Subject: Submittal of report, "Effect of Environment on the Corrosion of Waste Package and Drip Shield Materials" (CNWRA 2001-03), Intermediate Milestone 01402.571.170

RESPONSES TO NRC COMMENTS ON IM 01402.571.170

“EFFECT OF ENVIRONMENT ON THE CORROSION OF WASTE PACKAGE AND DRIP SHIELD MATERIALS”

Figure 2-3. Relative humidity(RH) at saturation of an aqueous solution of NaNO_3 and NaCl at 25°C (Ge et al., 1998) (MDRH = mutual deliquescence RH)

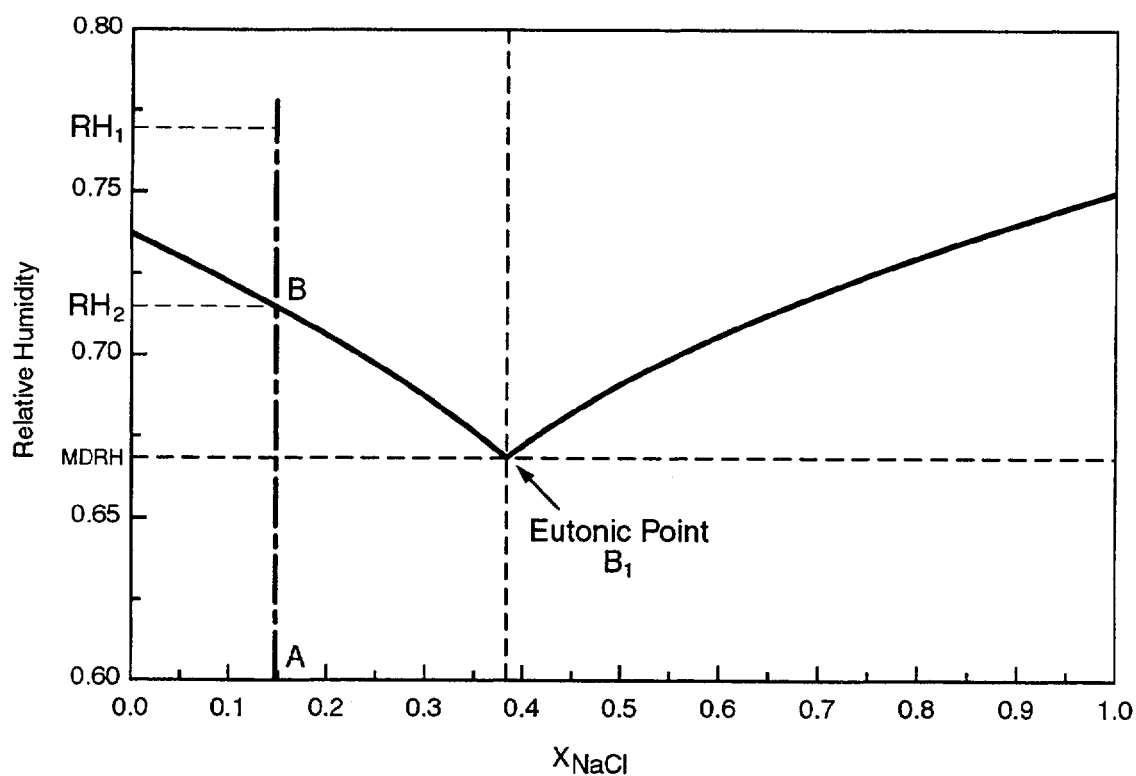
9. **Discussion of Deliquescence Behavior is lacking fundamental explanation since solid sodium nitrate must be precipitating for the solution to become enriched in sodium chloride for the liquid to go from 15% sodium chloride at B to 38% sodium chloride at B1 in Figure 2-3. A solidus curve should be added to the figure to define the solid + liquid phase region.**

Figure 3-5. U.S. Department of Energy predicted mean dose rate as a function of time for the basecase corrosion rate, and the 5th and 9th percentile median corrosion rates is fixed at the 5th and 95th percentile values of the uncertainty variance

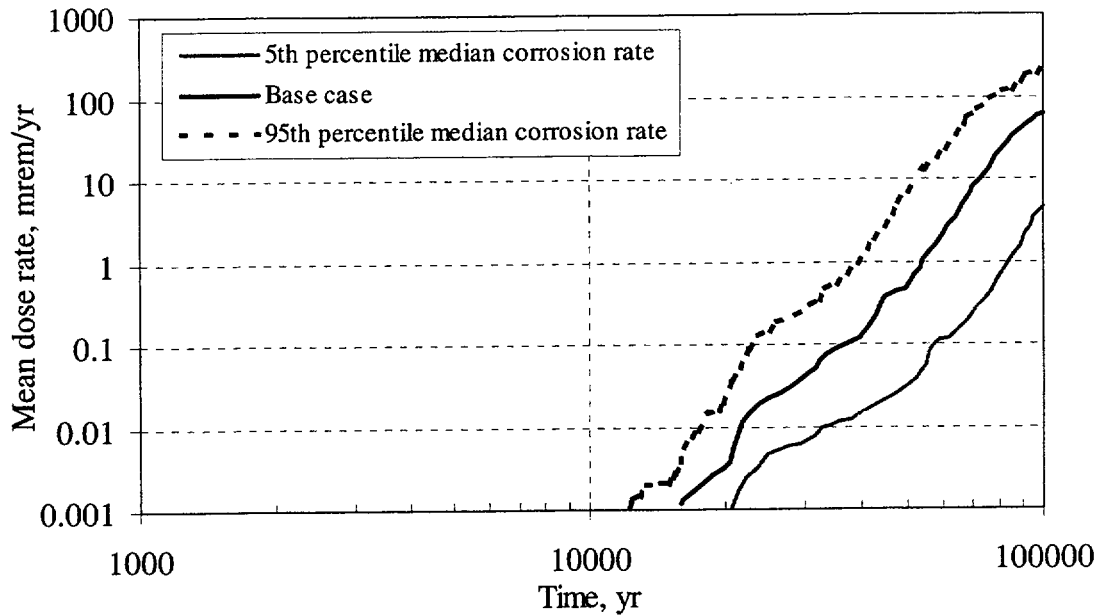
8. **Page 3-12. 2nd paragraph. Last sentence. “and the maximum dose rate at 100, 000 yr is 2×10^{-2} mrem/yr (figure 3-5).” That is 0.02 mrem/yr, not 200 mrem/yr as indicated in the figure. Should be 2×10^2 , not 10^{-2} .**

Accept, change made.

Figure 3-11. Metal ion concentrations measured using capillary electrophoresis from the anodic dissolution of Alloy 22 at 500 mV_{SCE} in 0.028 M chloride at 95 °C

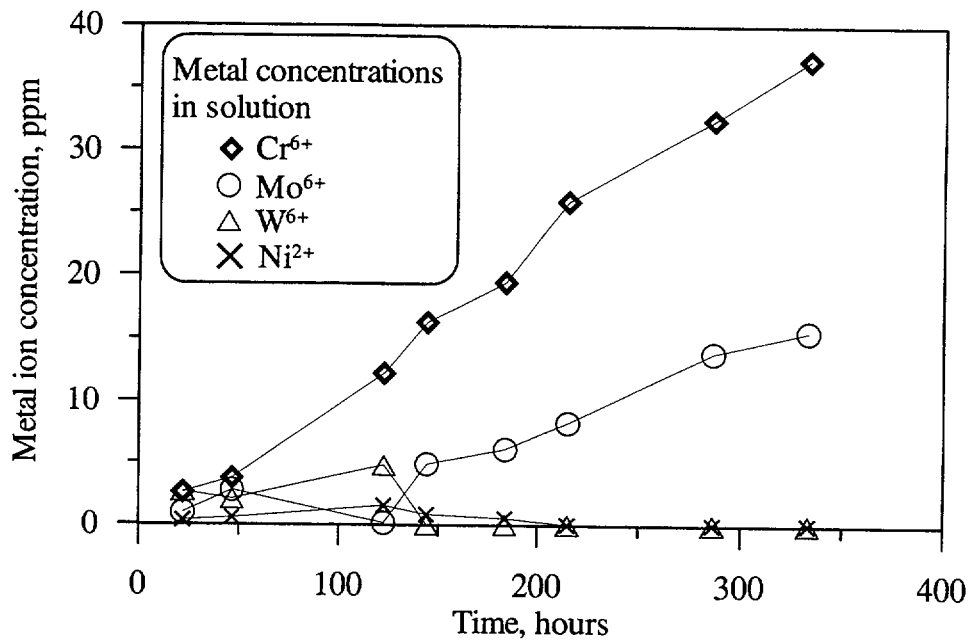
10. **Page 3-22. Figure 3-11. Graph label typo on X-axis.**

Figure 4-5. Predicted drip shield failure times using WAPDEG for the basecase (mean), and enhanced (5th percentile) and degraded (95th percentile) drip shield cases (Civilian Radioactive Waste Management System Management and Operating Contractor, 2000h)

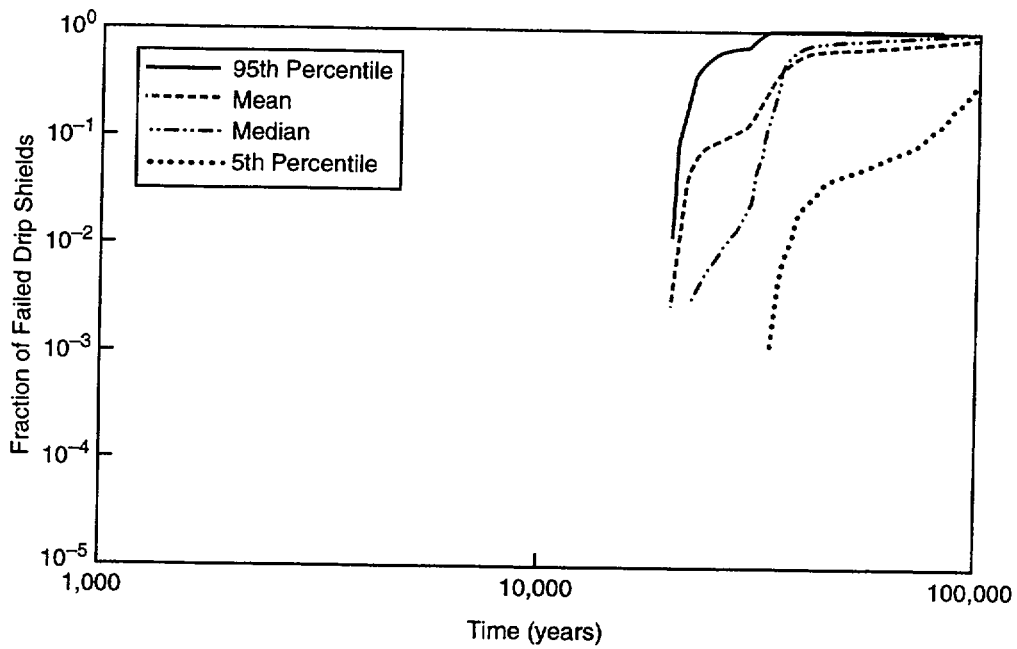
15. **Page 4-8. Figure 4-5. The graph cannot stand alone. The legend needs addition information. Suggest adding Degraded case to 95th percentile and Enhanced Case to 5th percentile. The chart is explained in the text, but the chart alone is insufficient.**

Accept. These are, however, DOE figures and we should be careful about altering them. Consequently, no change to the figure was made but the figure caption was modified to help clarify.

Figure 4-9. Effect of fluoride on the passive current density for Ti Grade 7 over time in a deaerated, 1 M NaCl solution at 95 °C and an applied potential of 0 V_{SCE}

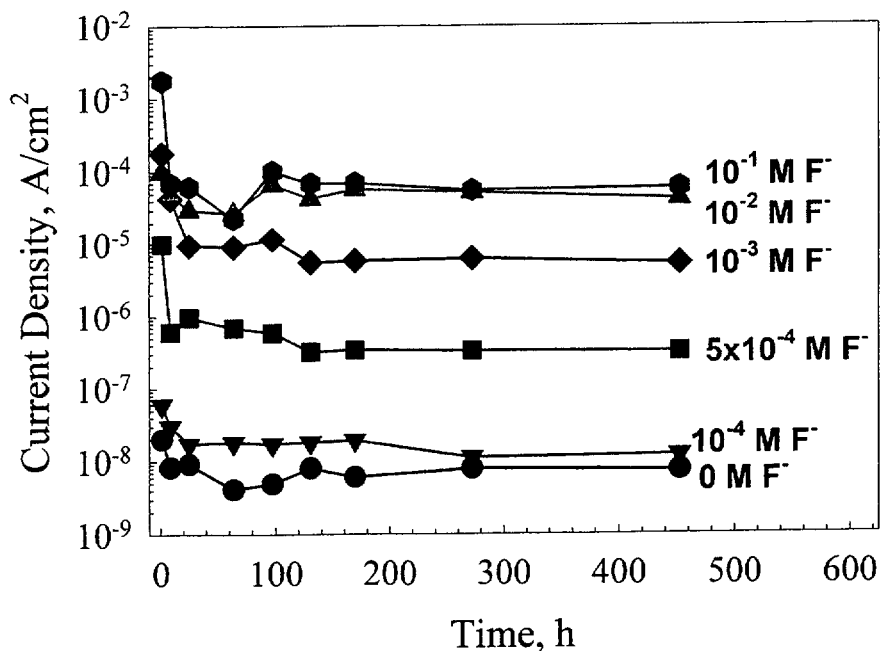
16. **Page 4-12. 1st paragraph, 2nd line. The plateau is at 10^{-2} or 10^{-1} ? It looks like 10^{-1} from the graph (figure 4-9), but I am not certain.**

The difference between 10^{-2} and 10^{-1} is relatively small and the rate of change is decreasing sharply between these concentrations. Thus, even though a slight increase in the passive current density was observed when the fluoride concentration was increased from 10^{-1} to 10^{-2} it seems more likely that the start of the plateau is at or very near 10^{-1} .

Figure 4-19. Cathodic polarization of Ti Grades 2 and 7 in a simulated crevice solution of 5 M NaCl, 0.1 M HCl, at 95 °C

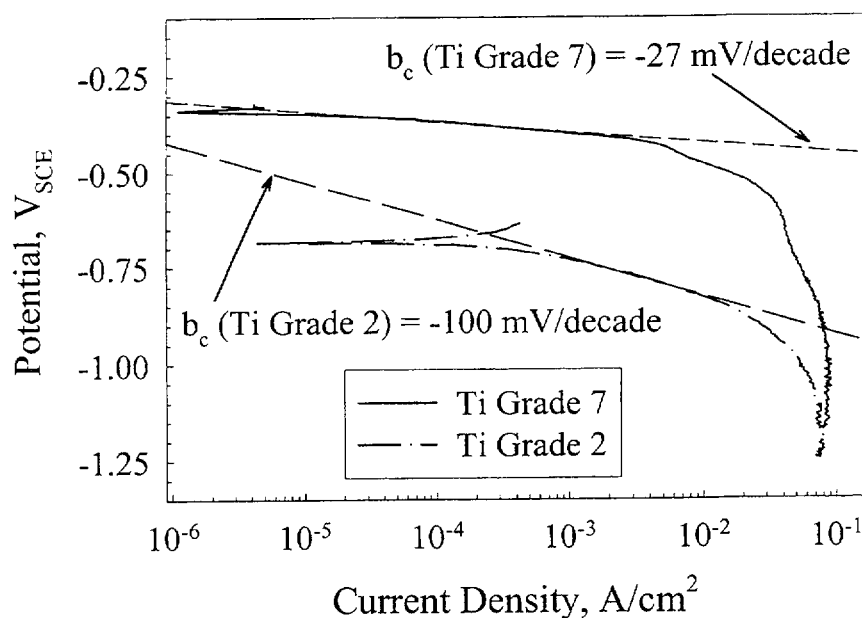
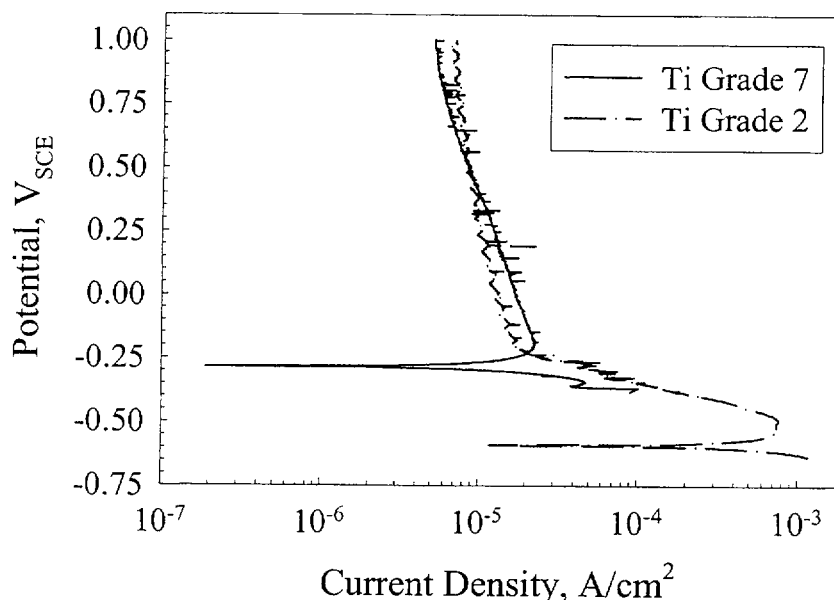
31. **Page 4-19 Numbering problem -- Figures 4-19 and 4-20, not 4-18 and 4-19 (also page 4-20, Figure 4-19, not 4-18).**
